R23CU: Right Front Barrier Securement

Models Affected: Certain 2015-2025 Model Year All American Rear Engine School and Non-School Buses

FIG 2

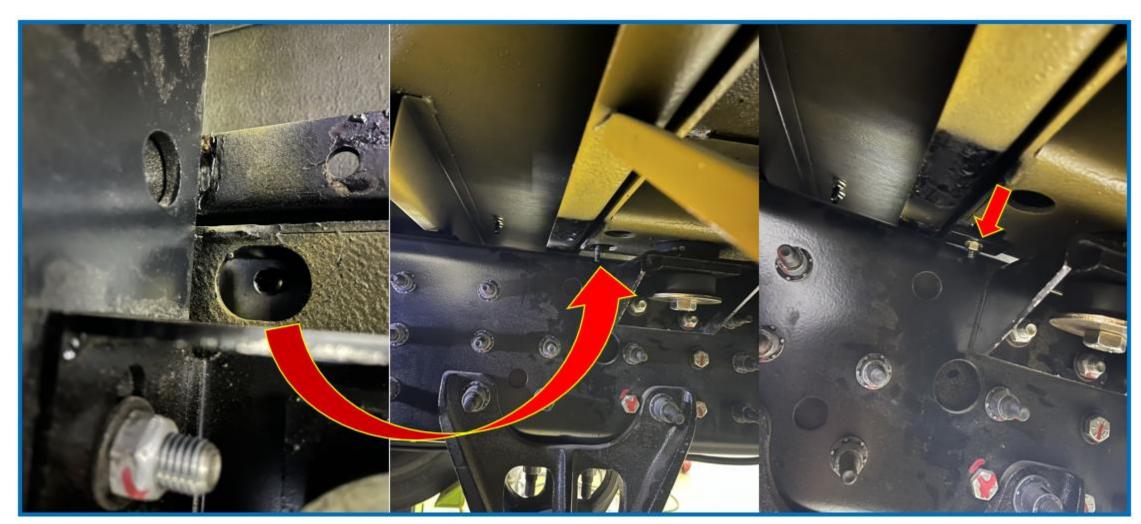
Issue: The installation of the front restraining barrier on the right-hand side behind the entrance door in certain All American Rear Engine School and Non-School Buses may not satisfy the requirement of FMVSS 222.

Corrective Action: Remove existing barrier securement hardware and replace with updated hardware, per instructions below

2. Install new bolt, washer, and locknut per Fig 2. Torque to 18-20 Ft-Lbs
